STAFF REPORT: REGULAR CALENDAR

APPLICATION NUMBER: 5-05-076

PROJECT LOCATION: 25 Quarterdeck Street, Venice, City of Los Angeles.

PROJECT DESCRIPTION: Demolition of a one-story duplex, and construction of a three-level, 31-foot high (plus 40-foot high roof access structure), 4,682 square foot duplex with an attached six-car garage on a 2,888 square foot lot on a walk street.

PLOT PLAN & BASEMENT FLOOR PLAN

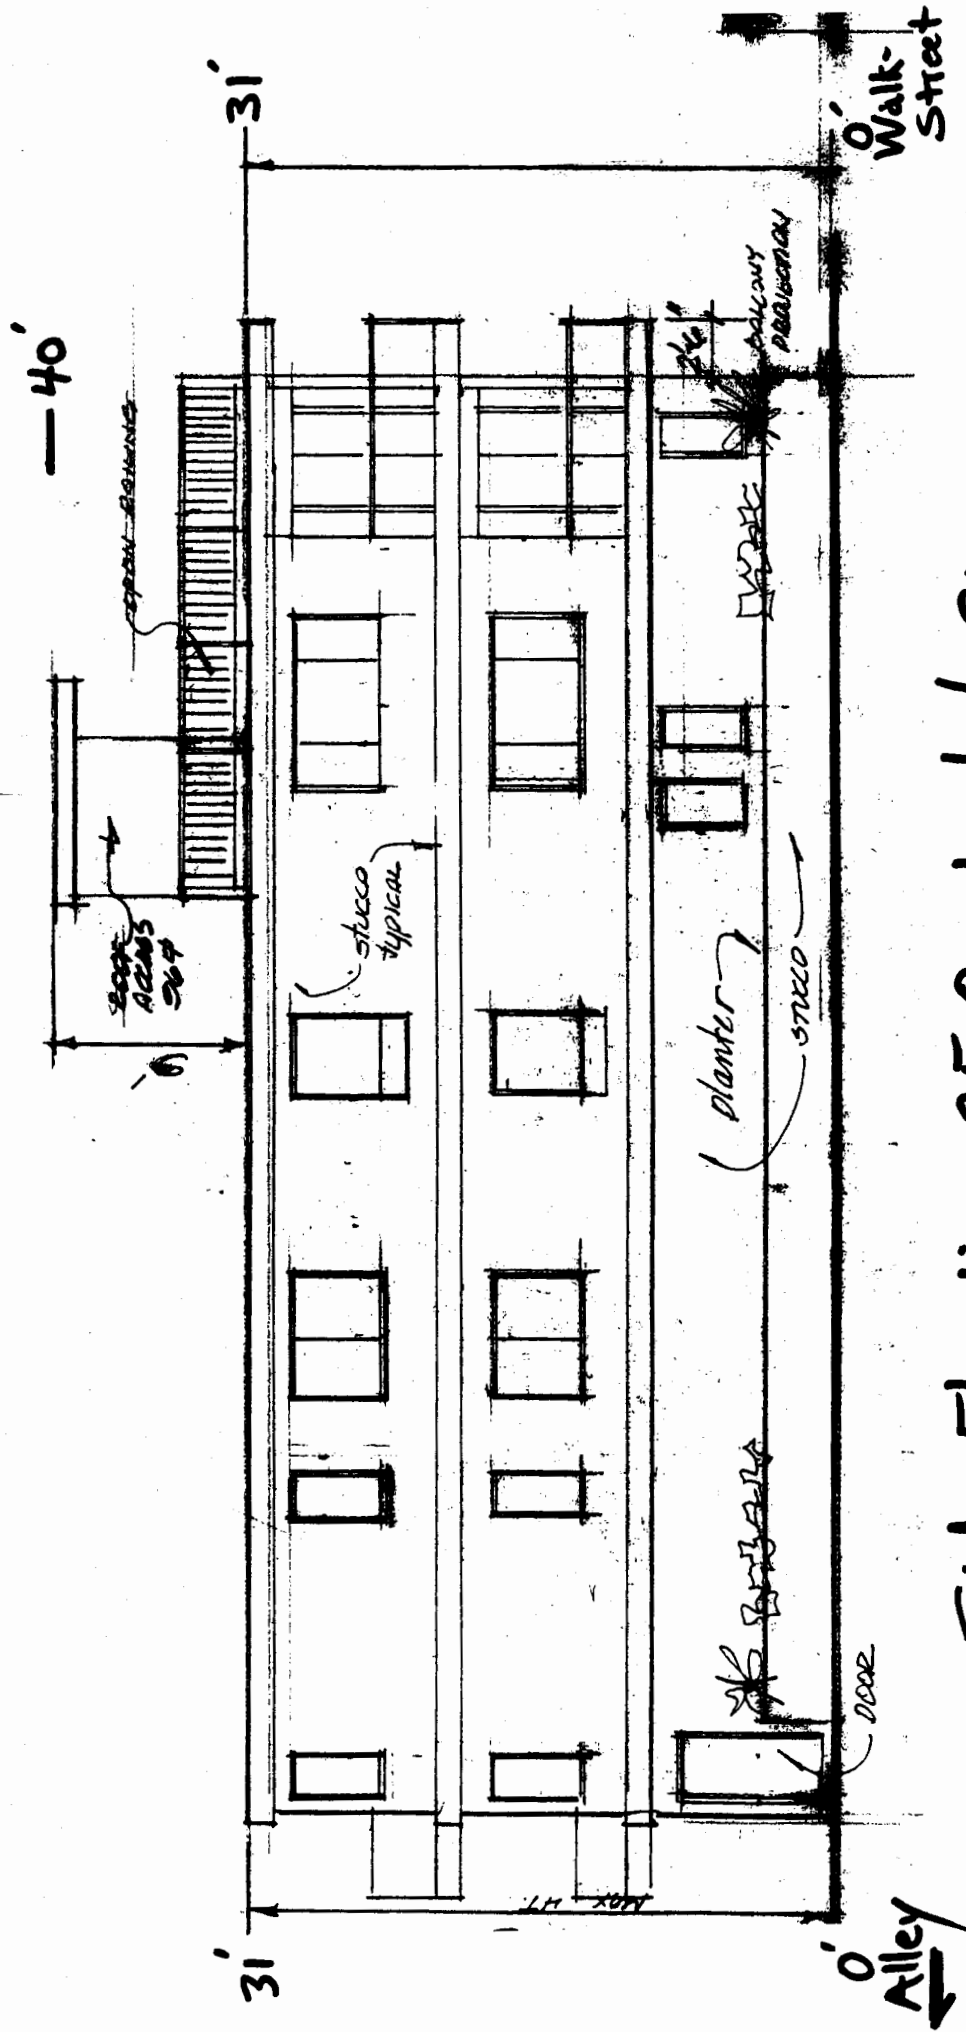
- (a) Building Setback. In order to maintain an open and visible access corridor and to enhance visual quality, all balconies and other portions of the structure (except for ground level decks and porches that do not exceed 18 inches in height above the elevation of the walk street sidewalk) shall be set back at least 12.5 feet from the Quarterdeck Street right-of-way, **as shown on Exhibit #4 of the 4/21/05 staff report.**

The proposed two-unit project includes an attached six-car garage, accessed from the rear alley (Exhibit #4). Therefore, the proposed project provides an adequate on-site parking supply and conforms to the parking standards for the Marina Peninsula neighborhood. The Commission finds that, only as conditioned to ensure the continued provision of adequate on-site parking, is the proposed project consistent with the public access policies of the Coastal Act.

EXHIBIT # 5
PAGE 1 OF 1

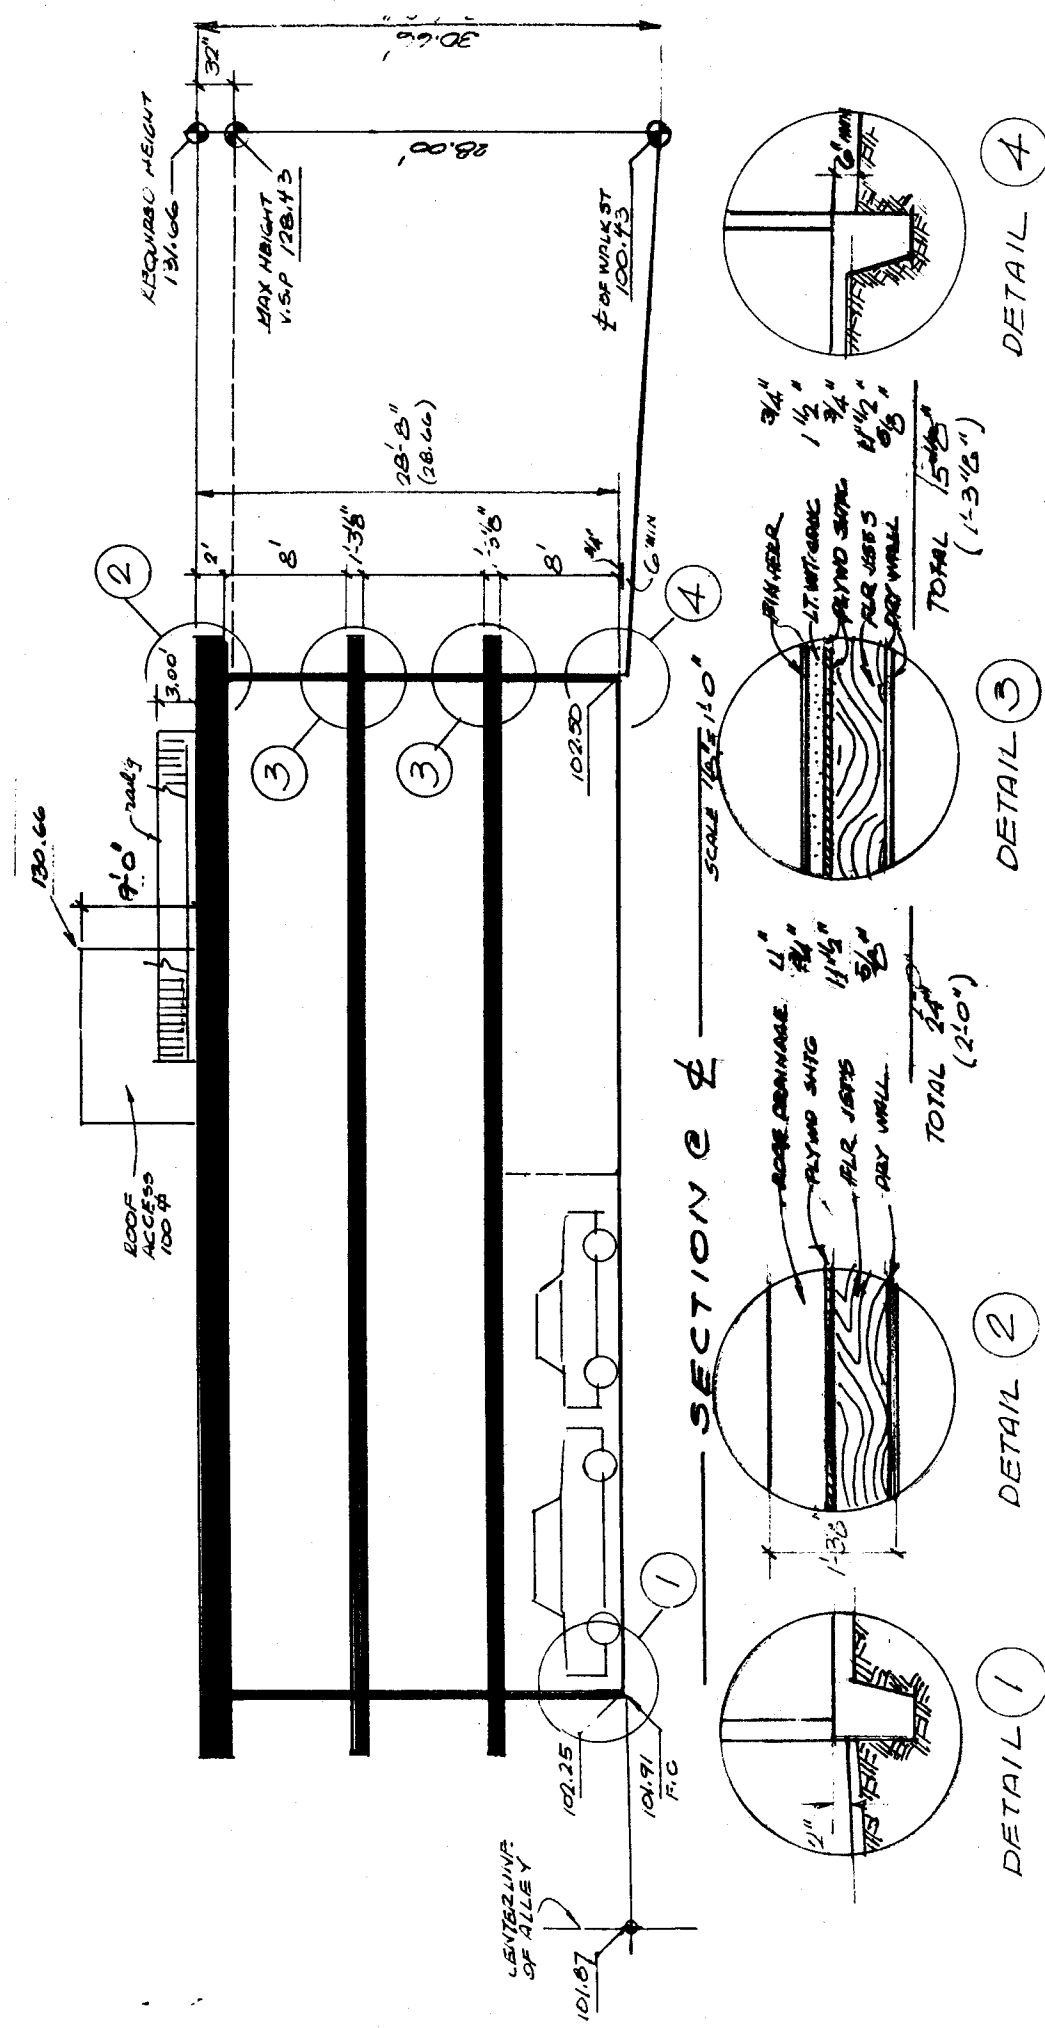
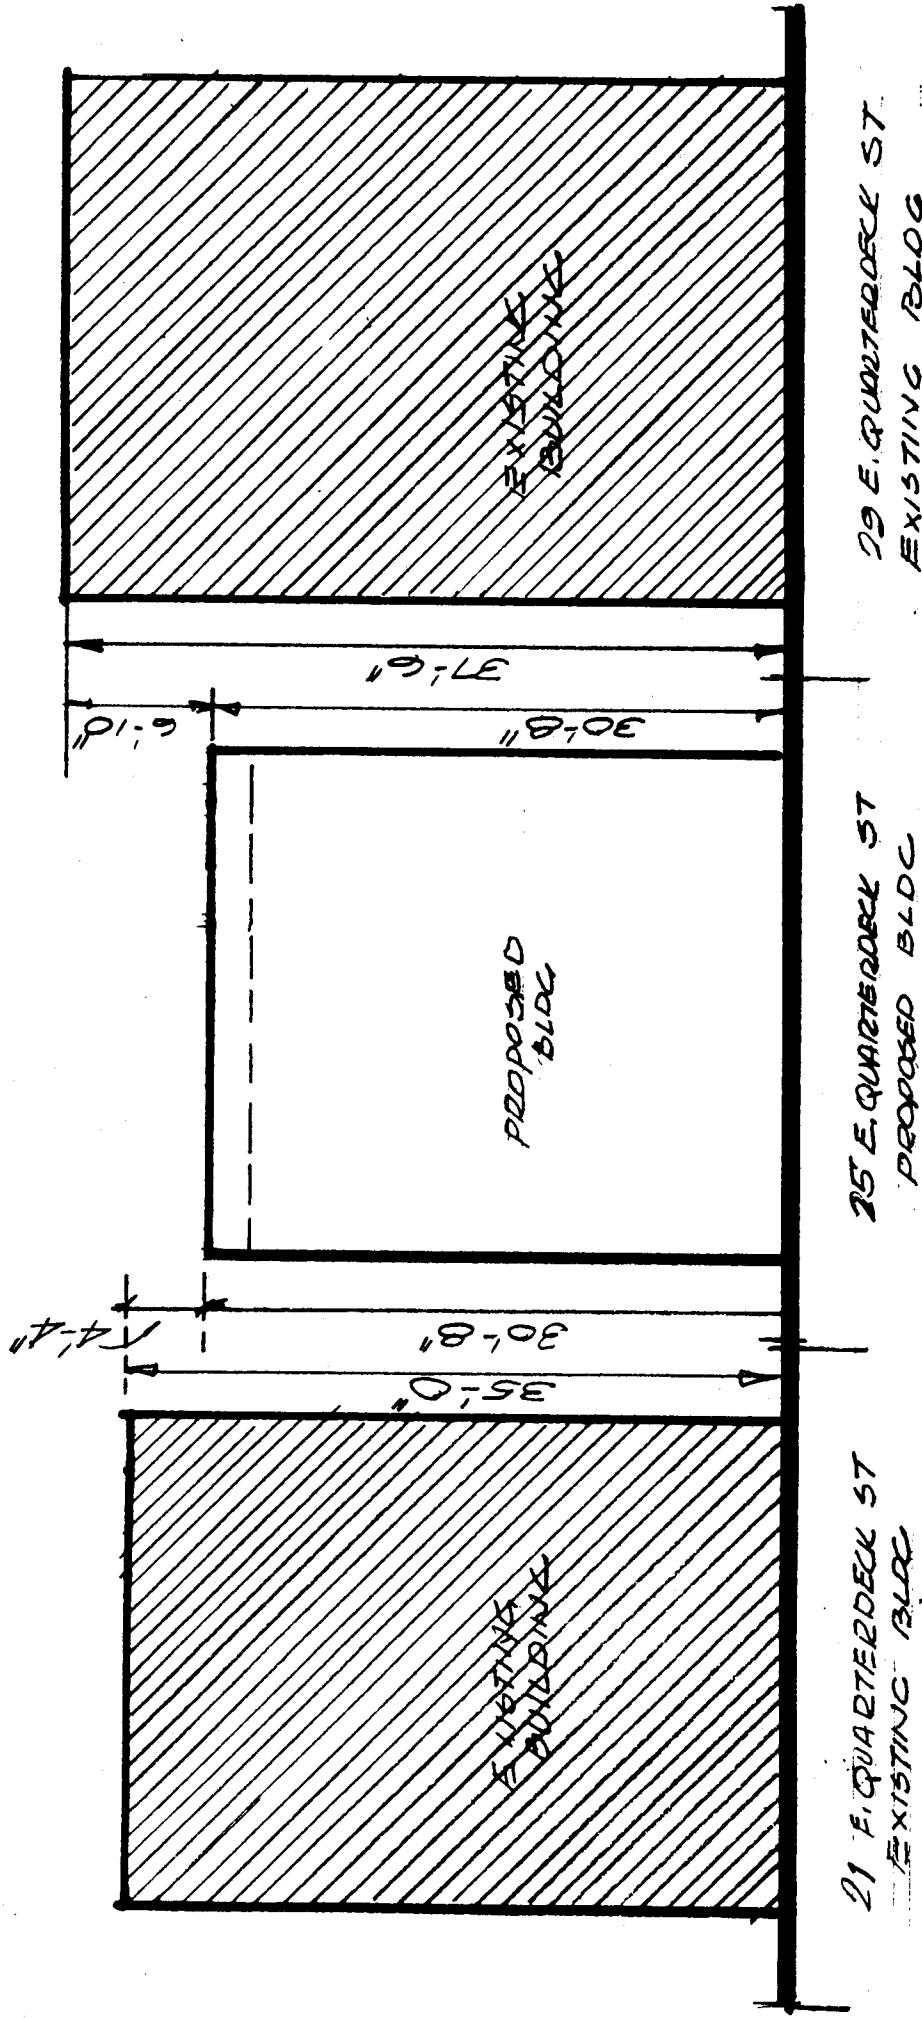
The maximum height of the structure shall not exceed 31 feet above the centerline of the fronting right-of-way (Quarterdeck Street), except for one roof access structure (stairway enclosure), with a footprint not exceeding one hundred square feet, which shall not exceed 40 feet in height, **as shown on Exhibit #5 of the 4/21/05 staff report**. Chimneys, exhaust ducts, ventilation shafts and other similar devices essential for building function are limited to 36 feet above the centerline of the fronting right-of-way.

EXHIBIT # 8
PAGE 1 OF 1

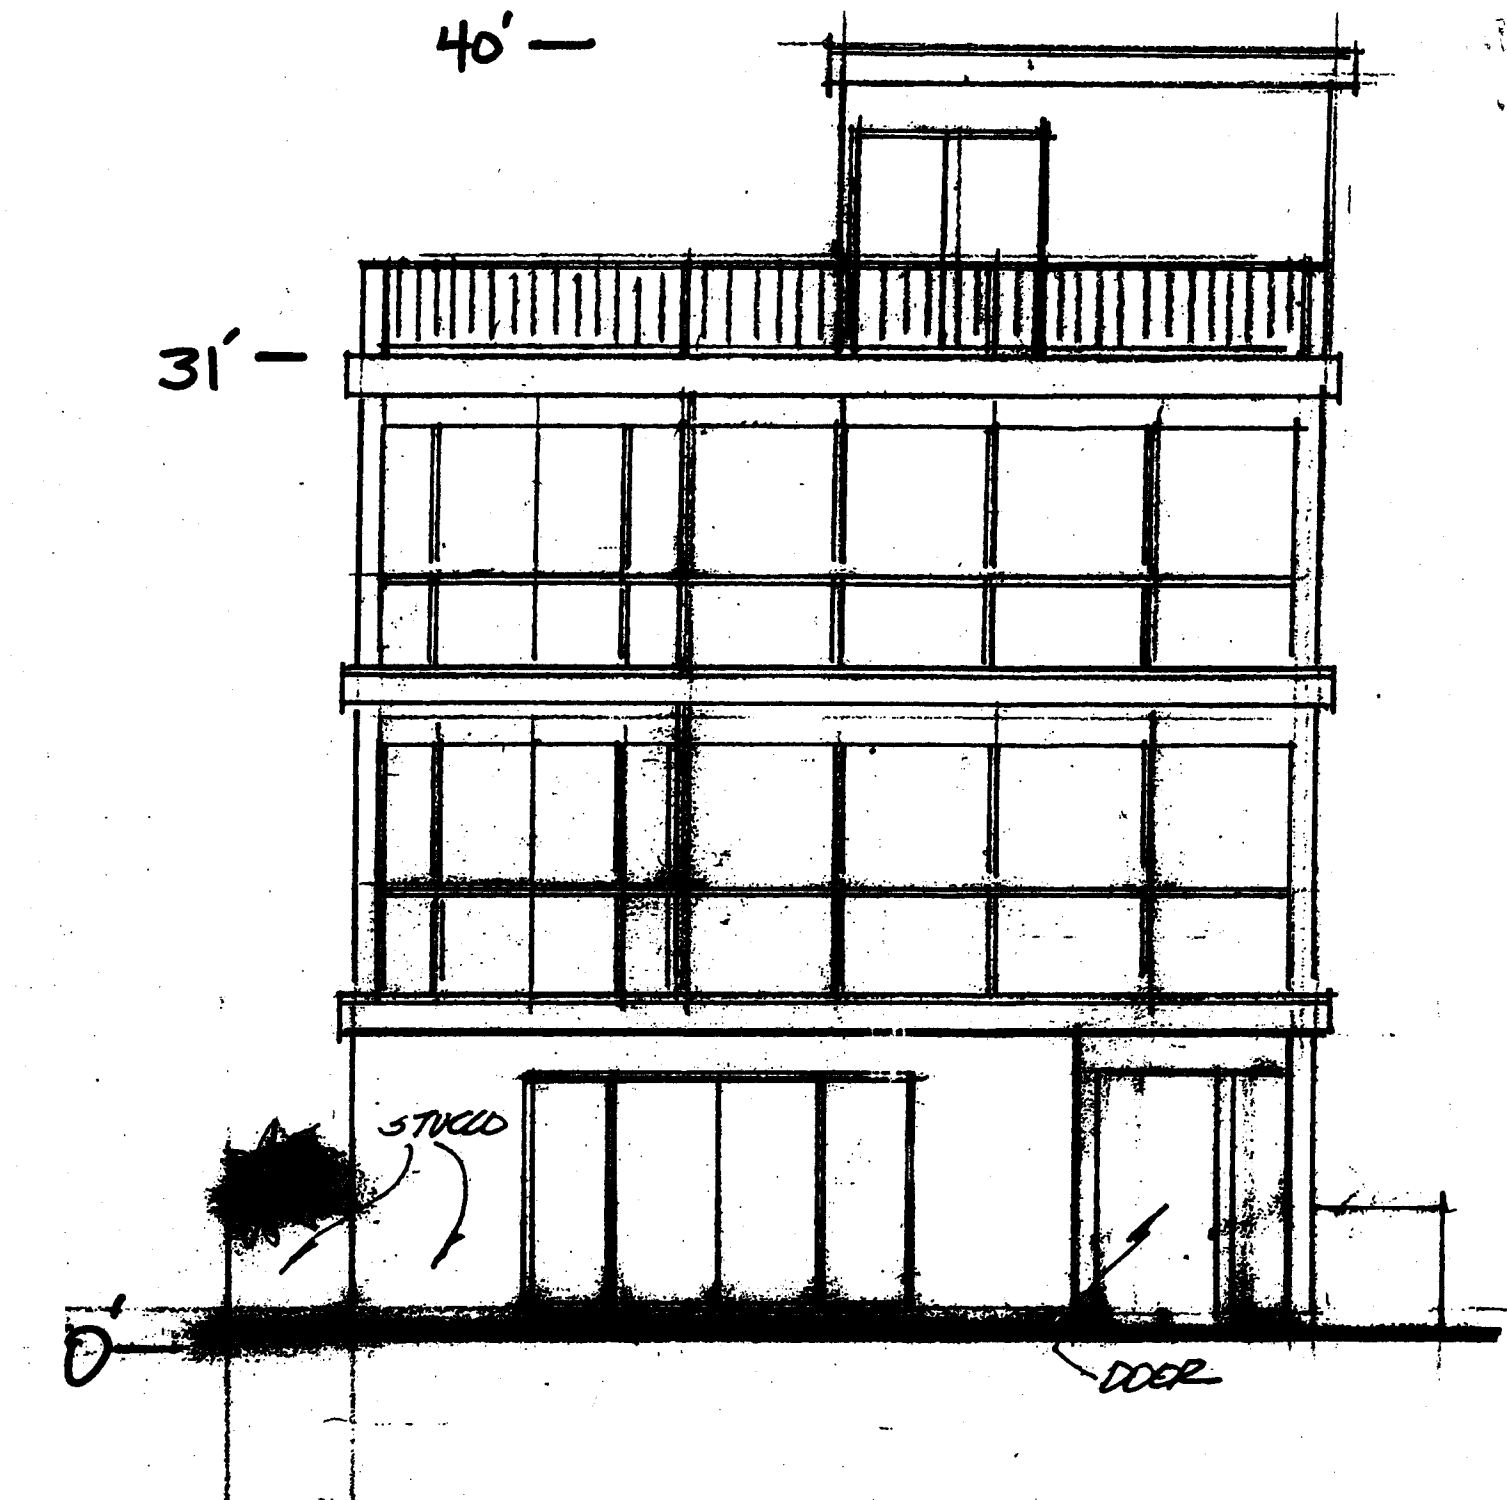
- (b) Building Design. In order to enhance visual quality and community character, the side of the building facing the Quarterdeck Street walk street shall be designed and constructed with a varied and articulated façade that provides visual interest to pedestrians (e.g. with porches, bays and/or balconies), with frequent windows and the primary ground floor entrance for the residence facing the walk street, **as shown on Exhibit #8 of the 4/21/05 staff report.**

In regards to compliance with the certified Venice LUP, the proposed project is consistent with certified LUP Policy II.C.10 which requires that new residential development along walk streets enhance both public access and neighborhood character. Public access and neighborhood character would be enhanced by the increased building setback and improved landscaping proposed to be provided along the Quarterdeck Street right-of-way. Quarterdeck Street leads directly to the beach. In addition, the proposed project's massing and scale would complement the existing structures in the neighborhood, and the proposed building's façade, with its primary ground floor residential building entrance, balconies and frequent windows facing the walk street, will provide visual interest to pedestrians as required by LUP Policy II.C.10 (Exhibit #8).
